Buildings B & C Proposed Final Design

DRB Comments from 1/4 meeting

ENLARGEMENT OF PLAN AT BUILDINGS B & C

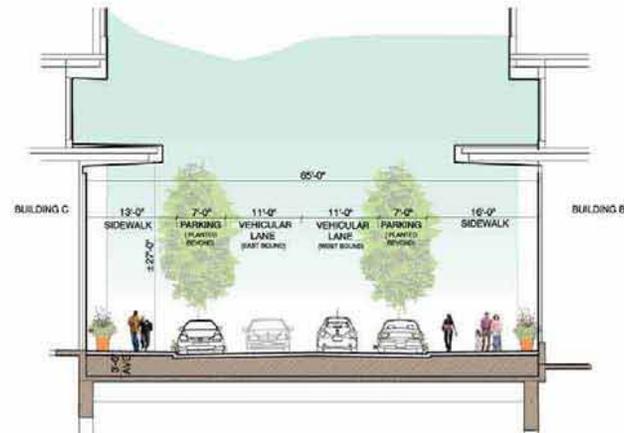
The DRB approved the applicant's response to their concerns, but would like LMN to explore shifting the street between Buildings B & C to the south in order to provide more open space / sidewalk along the south side of Building B.

ENLARGEMENT OF PLAN SOUTH OF BUILDING C

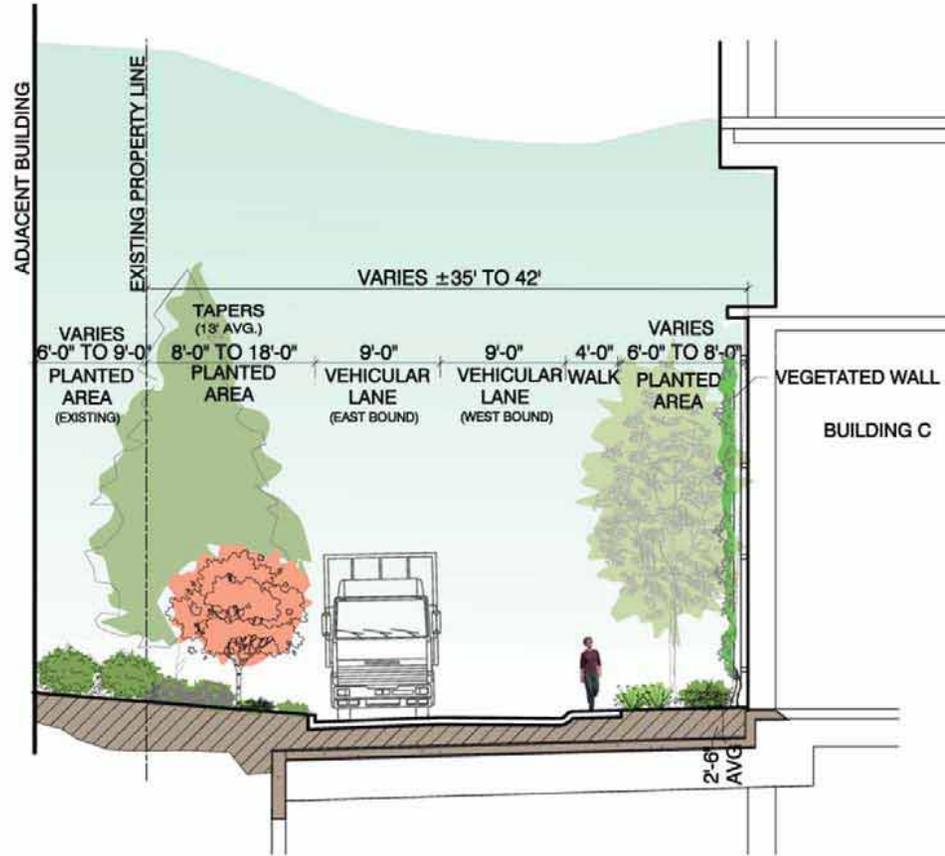
The DRB requested that the City and the applicant explore the possibility of adjusting the 10-foot landscape buffer requirement to provide more distance between the service drive and south side of building C, but indicated that any change should maintain or improve the landscape buffering for the Watermark apartments. The Board also felt that traffic calming devices should be investigated for the service street in lieu of adding a sidewalk for pedestrians.

The DRB requested that the City and the applicant explore the possibility of adjusting the 10-foot landscape buffer requirement to provide more distance between the service drive and south side of building C, but indicated that any change should maintain or improve the landscape buffering for the Watermark apartments. The Board also felt that traffic calming devices should be investigated for the service street in lieu of adding a sidewalk for pedestrians.

A - SECTION SOUTH OF BUILDING C

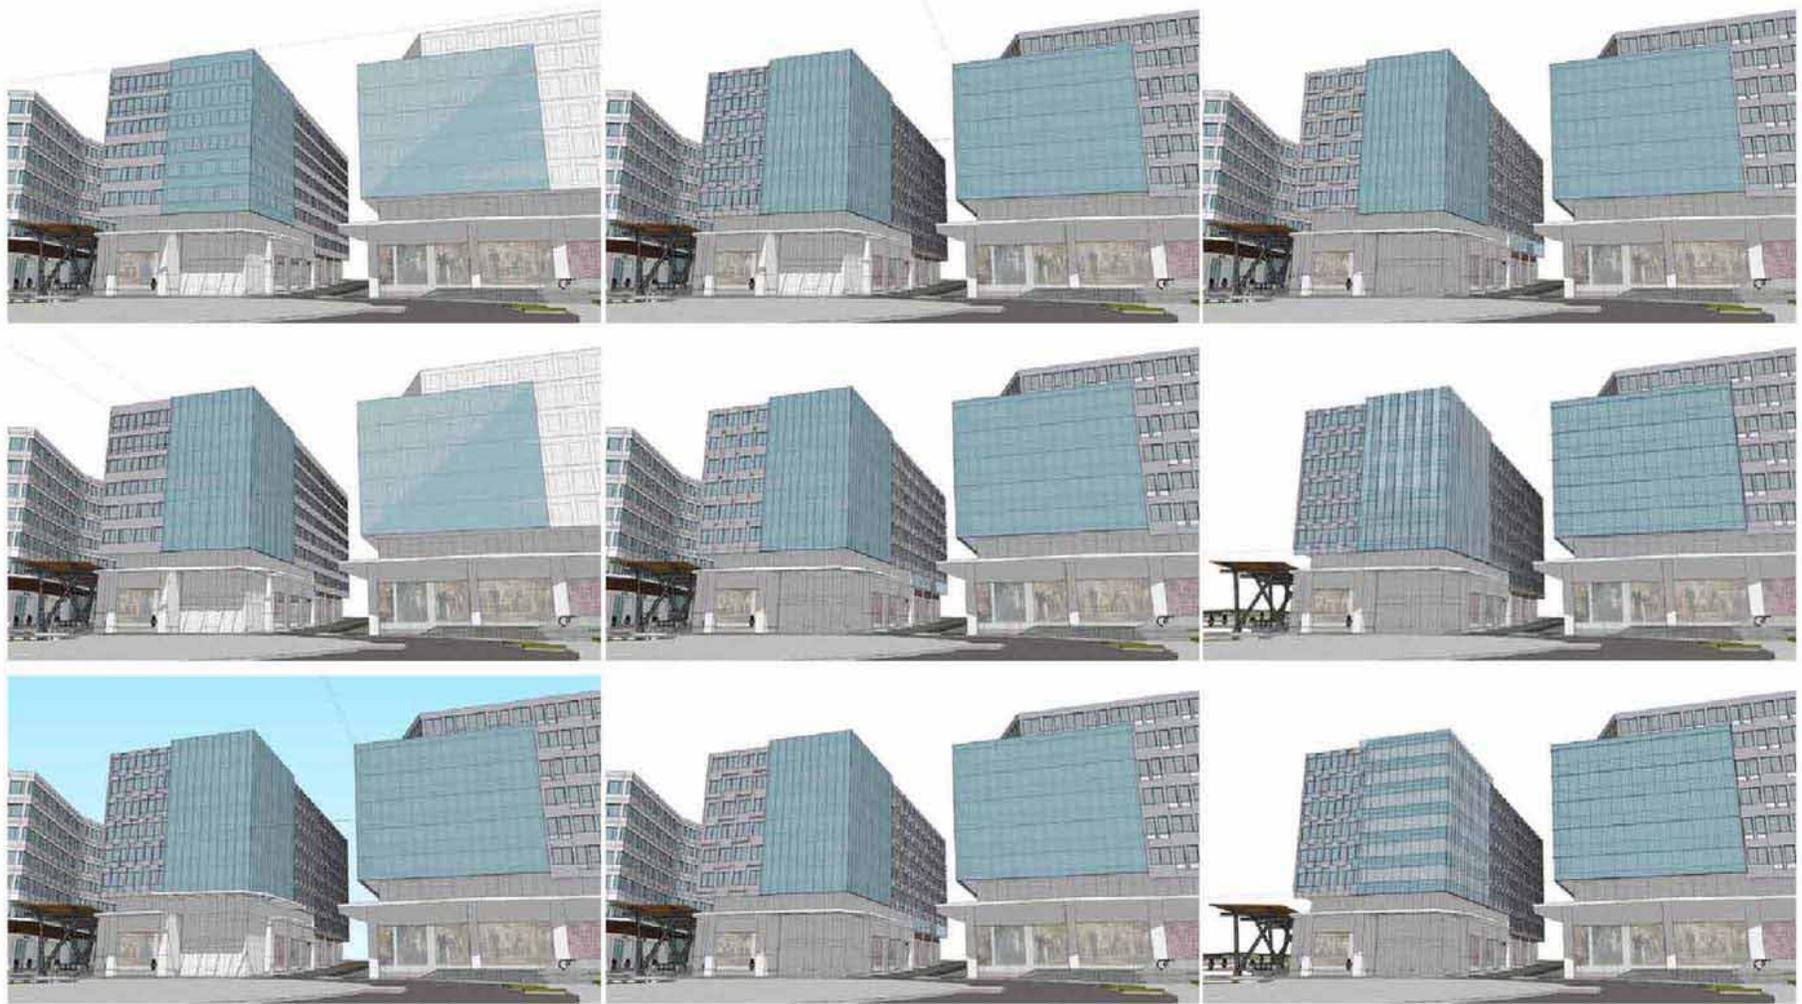
* a landscape or architectural screen should be incorporated along south east property line to buffer property from the adjacent residential use. (see design guideline on page 27 for exact location).

** an 8' pedestrian path is required along the established pedestrian connections on the southeast portion of the street.

Item A: West end of Building B is an important landmark

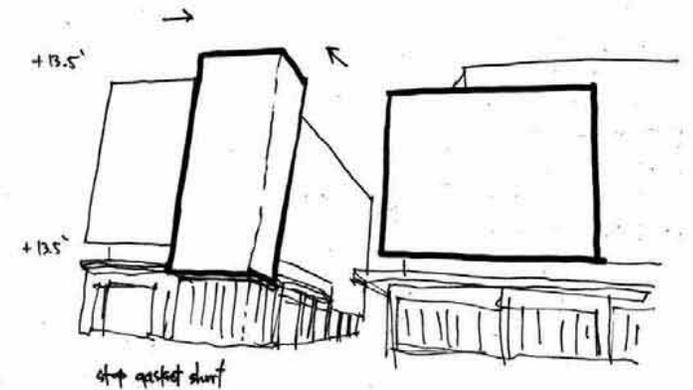
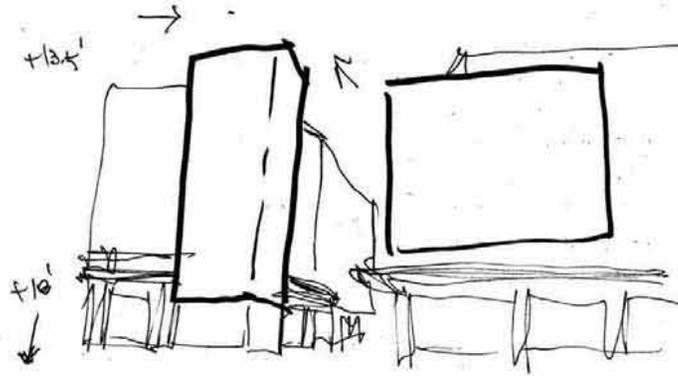
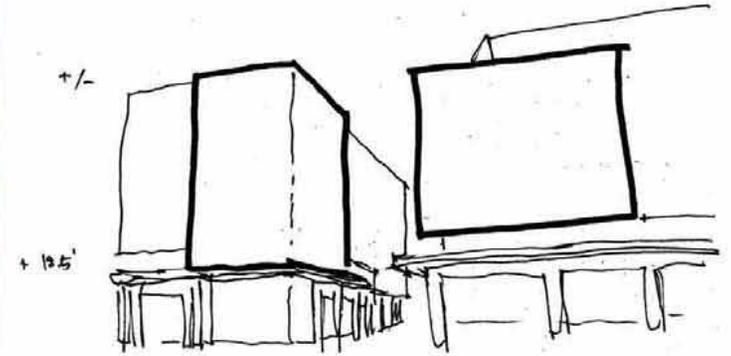
The DRB was in agreement with major massing moves made to the west sides of Buildings B and C [vertical and horizontal massing forms on corners]. The DRB requested that LMN consider ways of making the vertical element on Building B more dominant, such as stepping back the northwest corner [similar to north-west step-back on Building C] or allowing the vertical element to extend all the way to the ground plane with the removal/penetration of the gasket.
